2021-2023MY
Multiple Models

108**September 2023**

TECHNICAL SERVICE BULLETIN

SUBJECT: **4WD COUPLING ACTUATOR ASSEMBLY REPLACEMENT**

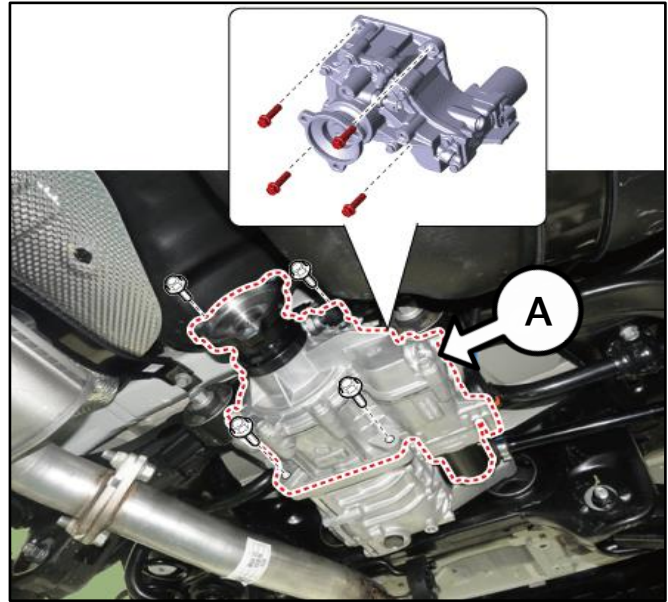
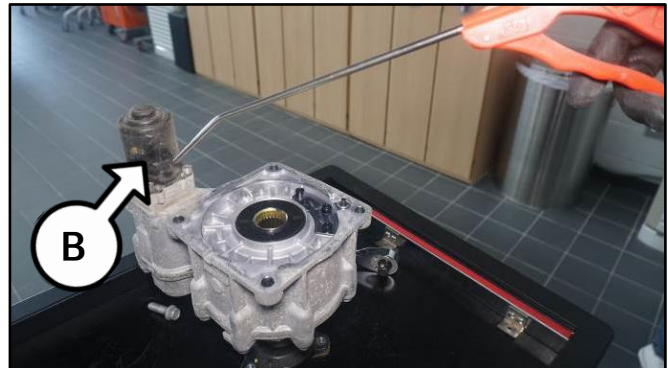
3. Remove the 4WD Coupling Assembly (A) by referring to the "4 Wheel Drive (4WD) System → Coupling Assembly → Direct Electro Hydraulic Actuator Coupling → Repair procedures" chapter in the applicable Shop Manual on KGIS.

Tightening torque for bolts:
41.9 - 47.7 lb.ft (58.9 - 64.7 N.m)

DO NOT tilt the AWD/4WD coupling assembly on its side or remove the actuator with the coupling assembly installed on the vehicle as the existing oil may leak out.

Only the rear side of the propeller shaft needs to be removed to remove the coupling assembly.

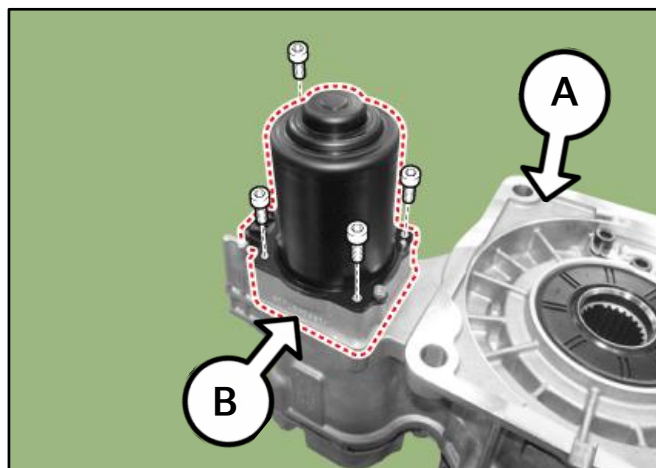
5. Loosen the four (4) bolts to remove the AWD/4WD coupling actuator (B).

Note: Keep the coupling assembly (A) in the vertical position.

Tightening torque for 4WD Coupling Actuator Bolts:
7.2 - 8.6 lb.ft (9.8 - 11.7 N.m)

DO NOT tip the 4WD coupling assembly on its side as the existing oil may leak out.

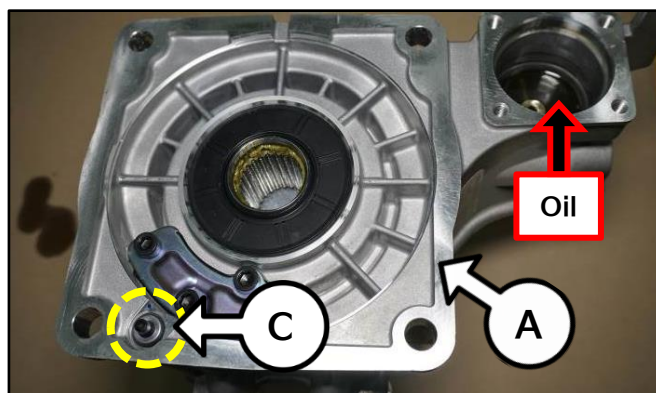
6. To avoid oil spillage from the actuator mounting area, press down on the air breather valve (C) to drain the accumulated oil back into the coupling assembly (A) housing.

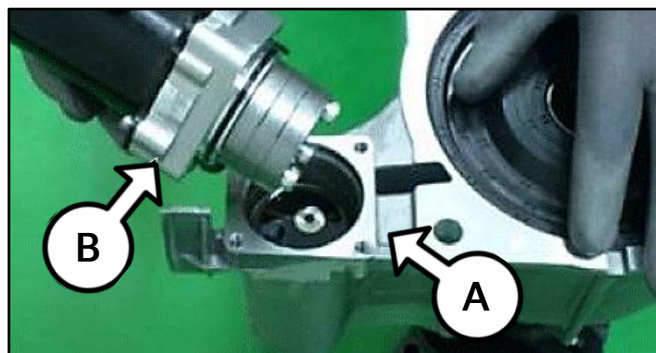
7. Install 'new' actuator (B) onto coupling assembly (A).

Note: Lightly lubricate the O-ring prior to installing the new actuator.

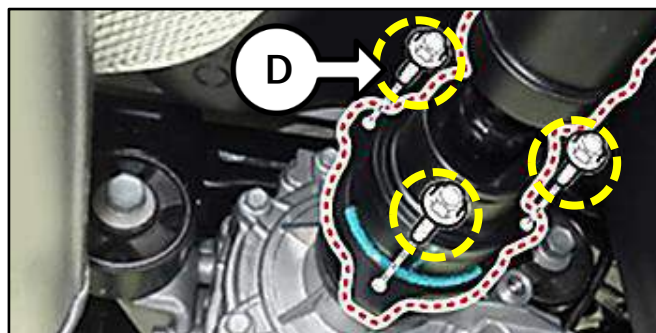
Note: Install 'new' mounting bolts (D) when reinstalling the propeller shaft.

DO NOT reuse the 'old' removed propeller shaft mounting bolts (D).
